OA	REVISED AS MARKED	OCT.04/13	SSE
0	RELEASED FOR FABRICATION	AUG.22/13	SSE
NO.	REVISION	DATE	BY
001	1	10/04/13	R.P.
002	2	10/22/13	J.M.
PROJECT NAME: FERRIER CENTRAL PROCESING PLANT			
CLIENT: DEVON CANADA C/O WORLEY PARSONS			
DOCUMENT NAME: SUCTION SCRUBBER SKID PIPING AND INSTRUMENTATION DIAGRAM			
THERMO DESIGN ENGINEERING LTD.			
OIL & GAS PRODUCTION EQUIPMENT DESIGN • FABRICATION • INSTALLATION EDMONTON, ALBERTA, CANADA			
APEGGA PERMIT NUMBER: P2820			
THIS DRAWING IS THE CONFIDENTIAL PROPERTY OF TDE AND IS ISSUED ON THE UNDERSTANDING THAT NOTHING IS TO BE COPIED OR COMMUNICATED TO A THIRD PARTY WITHOUT THE WRITTEN AUTHORIZATION OF TDE.			
TDE JOB NUMBER:	SCALE:	(FOR A1)	
12-150	-		
DOCUMENT NUMBER:	ITEM:	SHEET:	REV:
DFT-10-PR-PI-0001	-	-	0A

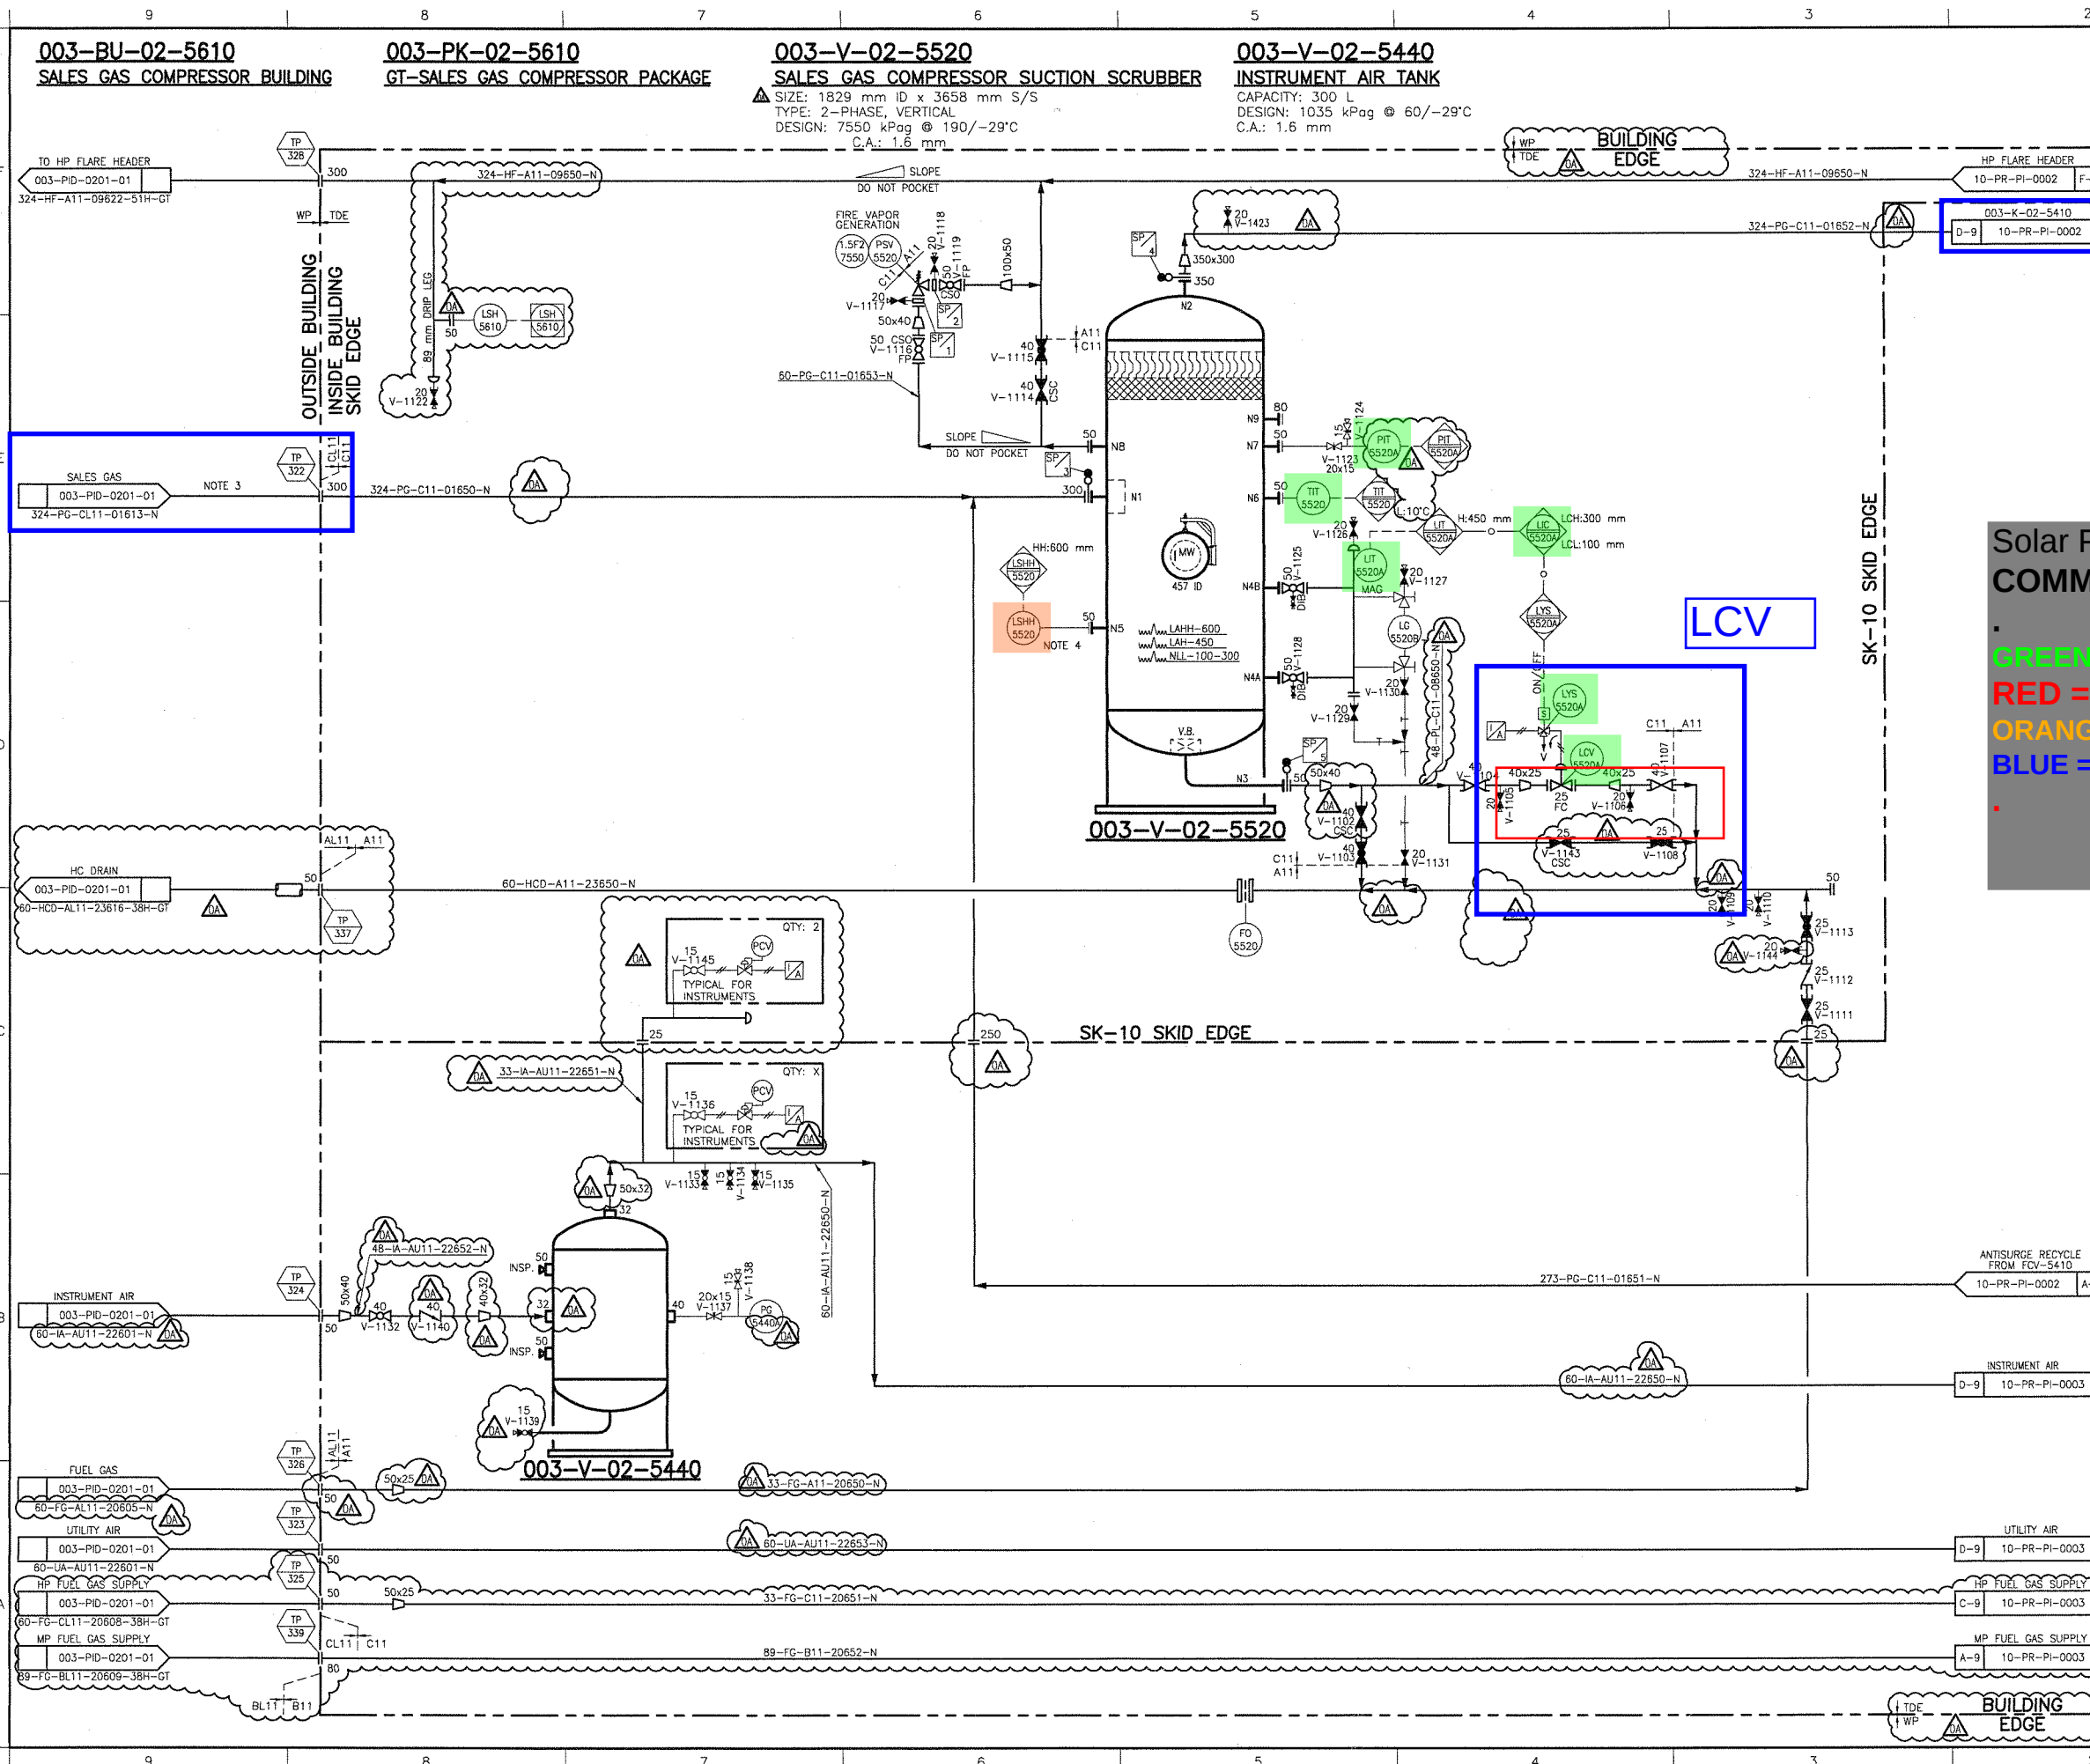
- GREEN = verified device on Solar BOP
- RED = correction/Q for TDE
- ORANGE = Not found in Solar BOP
- BLUE = (help) notes
